# FilaOut: VSI performance improvement and board checkout
## M. Wunderlich   21Oct2012-11-21   mwunderlich@mpifr-bonn.mpg.de

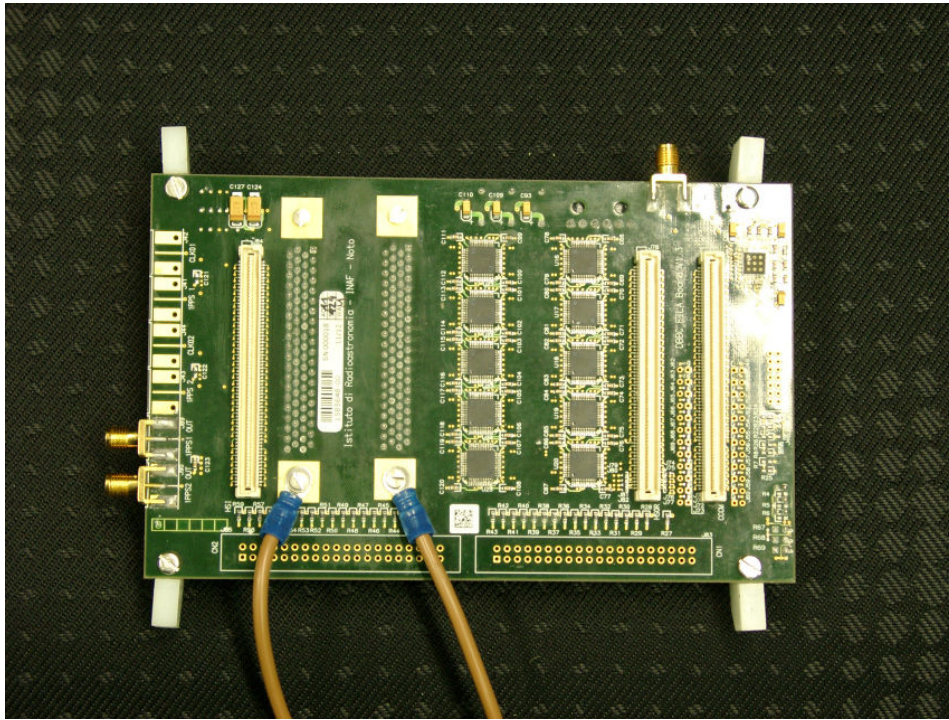
For some reasons the shielding of a VSI cable was not connected to the DBBC ground in earlier systems. This could produce common mode biases in the drivers and thus a strange behaviour of the VSI in some cases.

It is quite easy to correct this. Use 4 flathead screws M2.5 to fasten the VSI connectors to FilaOut board properly. Use two of these screws to connect ground straps to the rectangular copper area which is floating in respect to the system ground.
